## 3 Detailed description of change

Material change of the micro switch connections from copper to brass.

Product Change Notification					0118.2162	
creation date	created by	release date	released by	notification no.	revision	page
25.02.2013	MER	25.02.2013	MER	2446024460		1 of 2

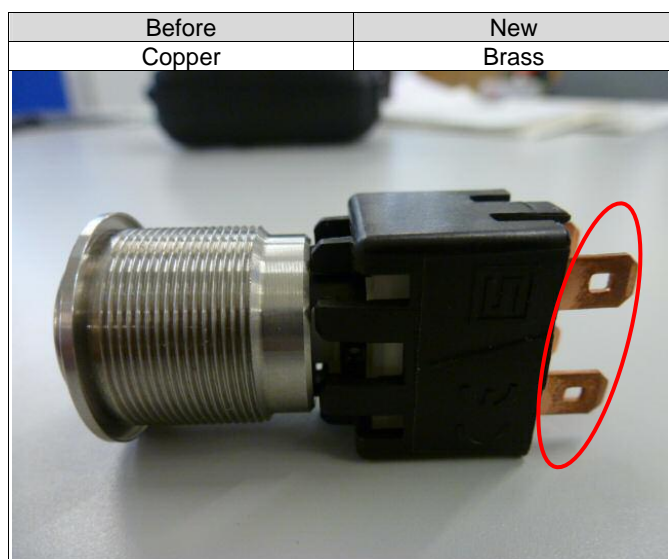
Form: No influence (new colour of contacts)
